LINCOLN COUNTY
DEPARTMENT OF ENVIRONMENTAL HEALTH
AFFIDAVIT OF WASTEWATER TREATMENT AND DISPOSAL SYSTEM COMPLIANCE REVIEW FOR SYSTEM INSTALLED, REPAIRED OR REPLACED WITHOUT A VALID PERMIT

Issue Date: 10/21/2020

Address or Location: 50 Billy Bobs Way Libby, MT 59923

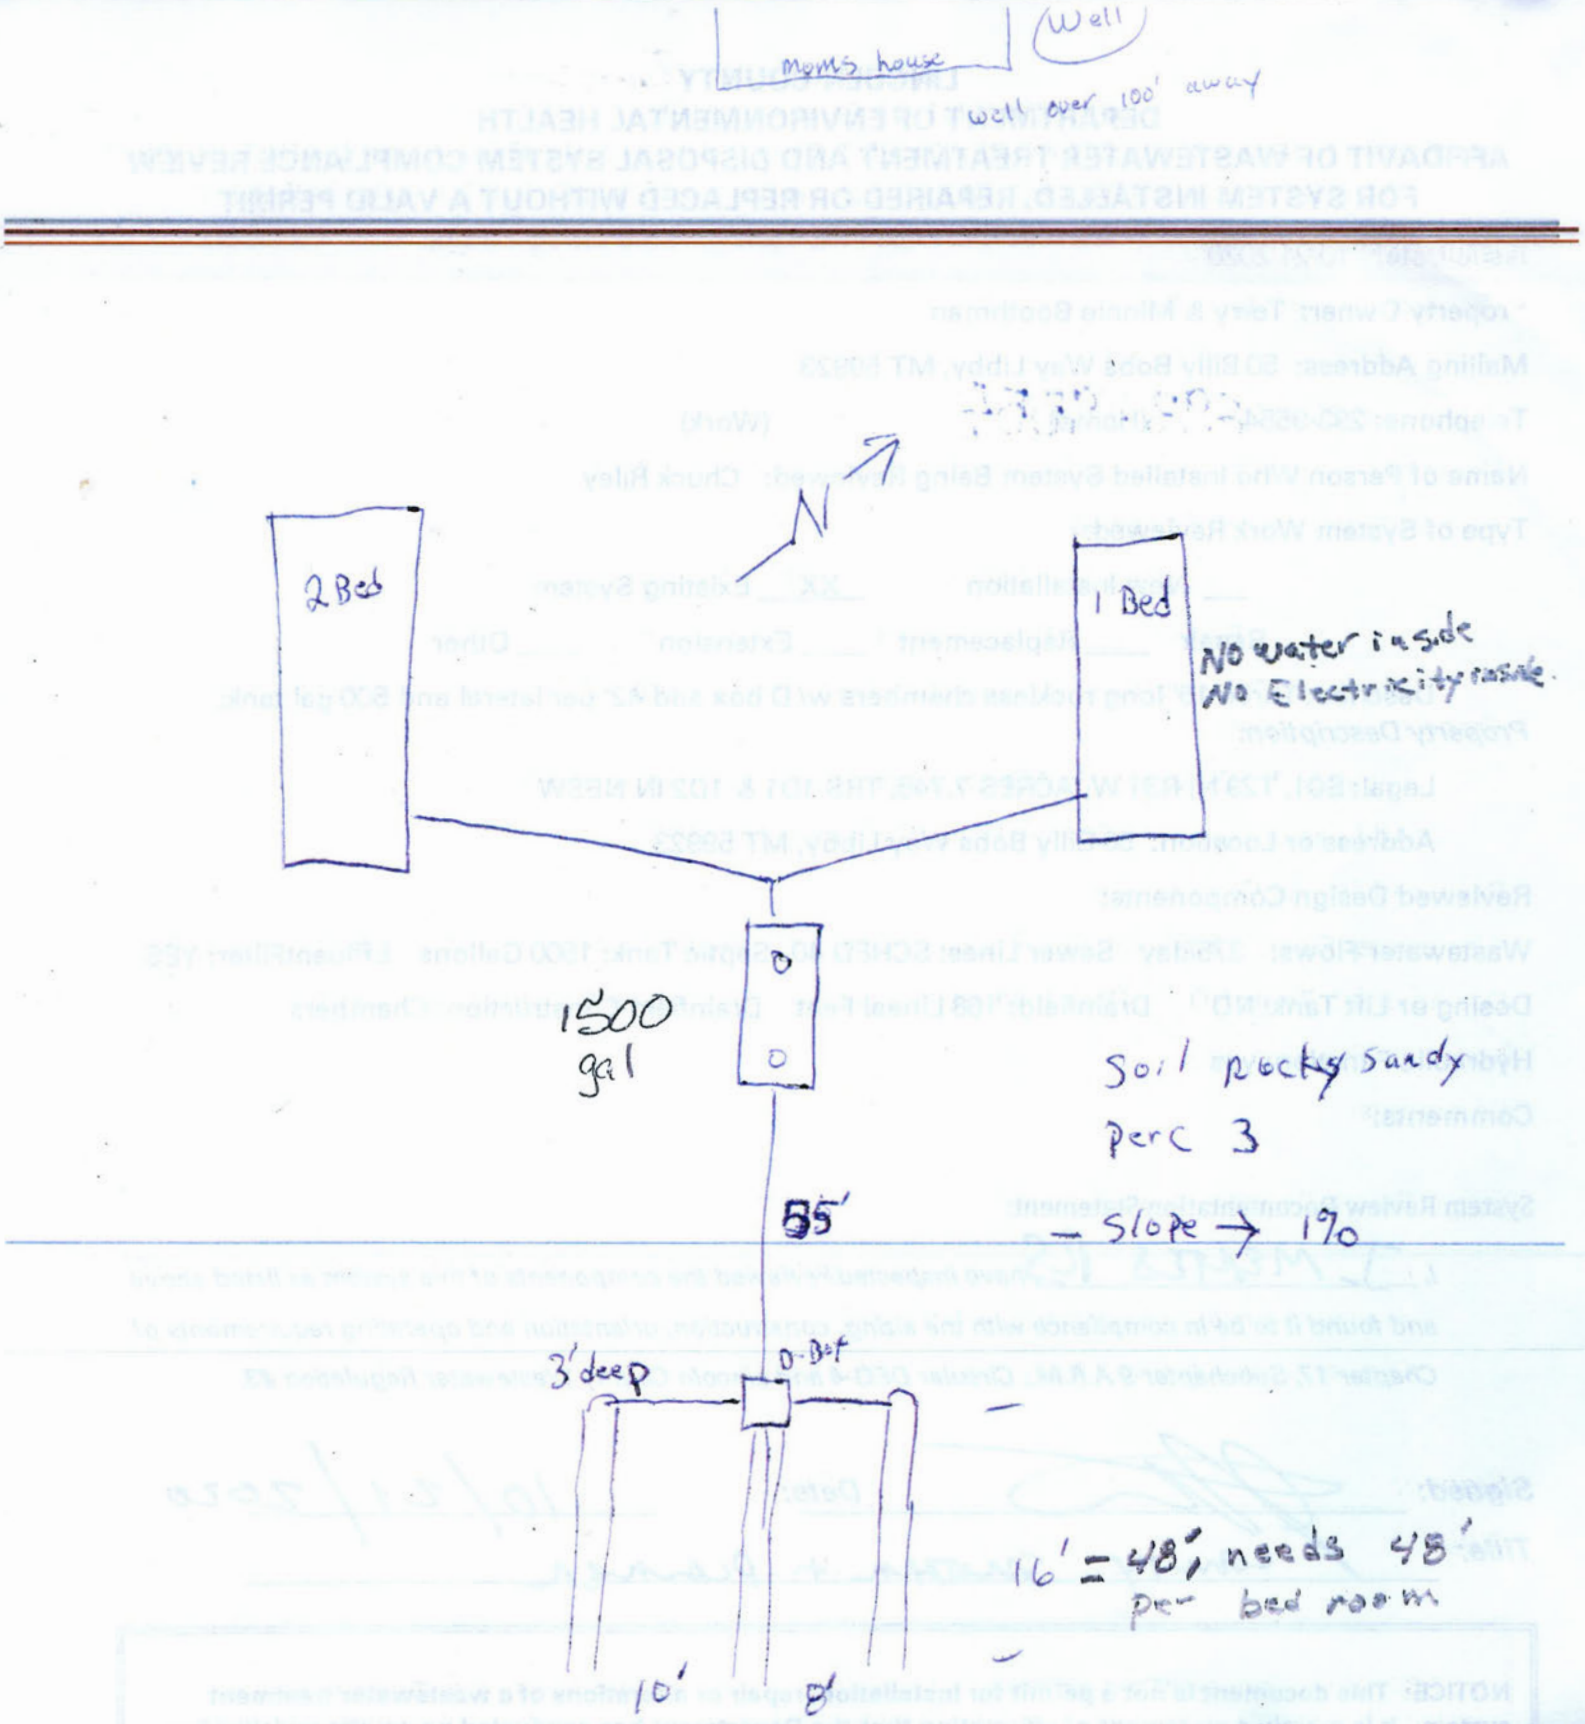
Moms house
Well
well over 100' away
N
2 Bed
1 Bed
No water inside
No Electricity inside
1500 gal
Soil rocky sandy
perc 3
55'
- slope → 1%
3' deep
0-Ref
16' = 48', needs 48' per bed room
10'
8'
bigger drain field
